Specific Design Plan

SDP-0318-H2

The Preserve at Piscataway, Lot 75 Block B

SUBJECT: Homeowner's Minor Amendment to Specific Design Plan SDP-0318-H2
Preserve at Piscataway, Edelen Village, Lot 75 Block B

SITE PLAN OF PROPOSED DECK

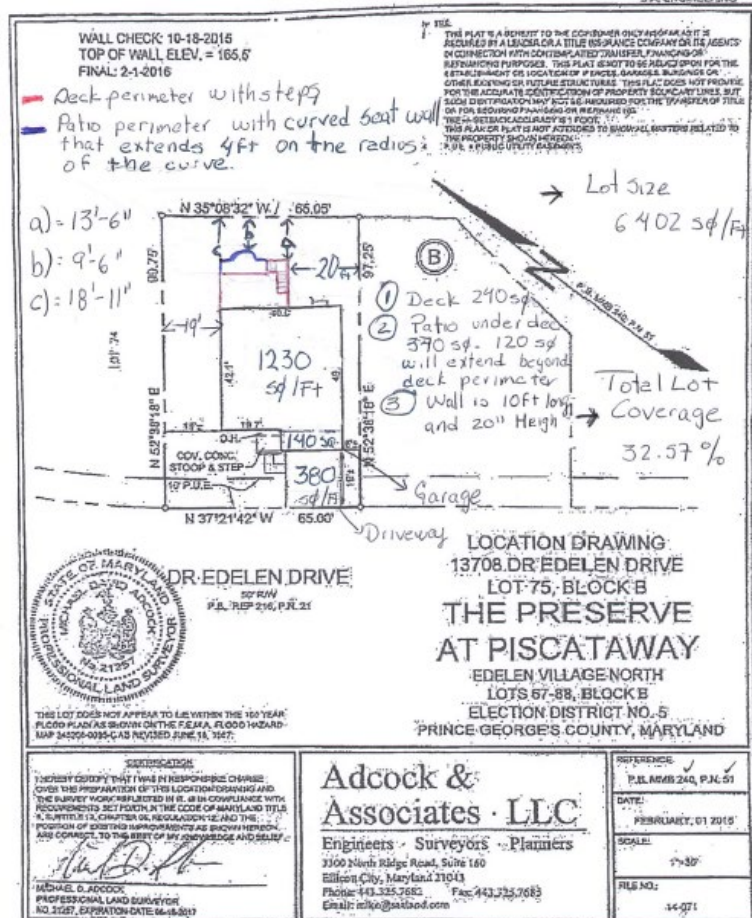
2. Draw the proposed deck, steps and landing onto the site plan, drawn to scale and label how far the elevated deck is from the side and rear lot line. A deck is an extension of the house and unless exceptions are provided, the deck must comply with the same setbacks as the house. The lot is in the Edelin Village of the Preserves of Piscataway. The lot is zoned Legacy Comprehensive Design (LCD) and the development regulations were determined by the approval of the specific design plan for Preserves of Piscataway, SDP-0318. The rear yard setback is 25 feet and there are no exceptions for the setbacks for the deck, therefore, the deck must be 25 feet from the rear lot line. Using the measuring tools available, the house is only 30 feet from the rear lot line. The deck will only be 18 feet from the rear lot line and will require the approval of a Homeowner Minor Amendment (HMA) to SDP-0318. To submit an HMA:

REAR ELEVATION OF PROPOSED DECK

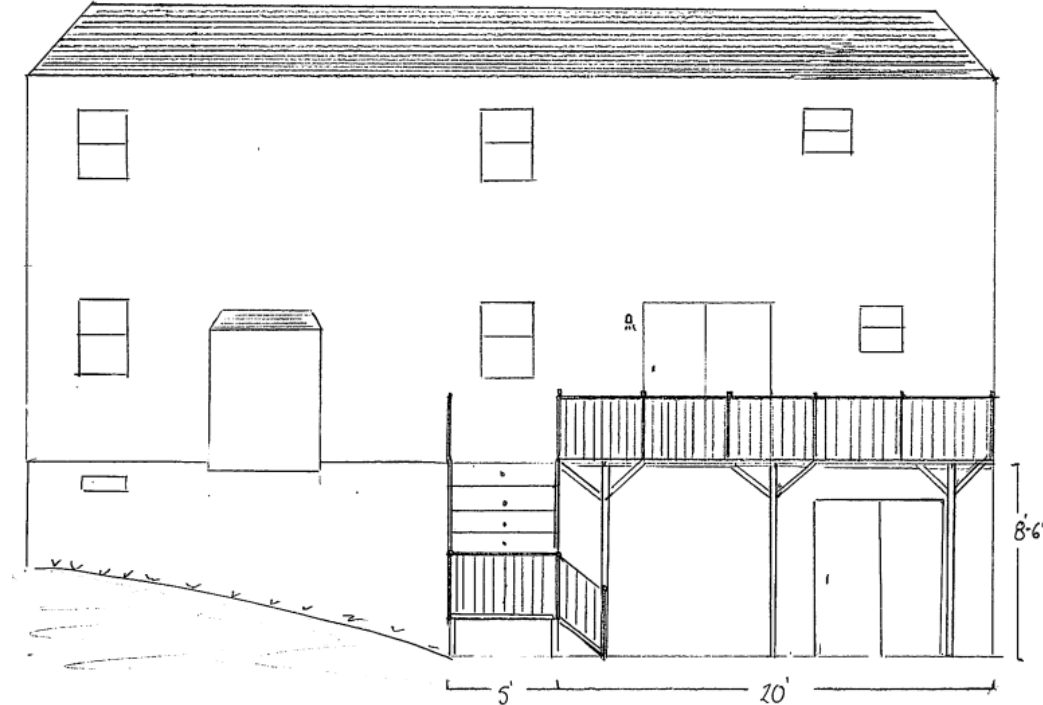
1. Provide detailed and scaled plans showing all components of the proposed deck addition, including dimensions of the proposed deck railings and the lower deck and wall.

1. Please provide side and rear elevations of the deck. It appears to be a 12 foot by 20 foot, elevated deck, with landing and steps to possibly a 5 foot by 20 foot ground level deck with a semi-circle bump-out.
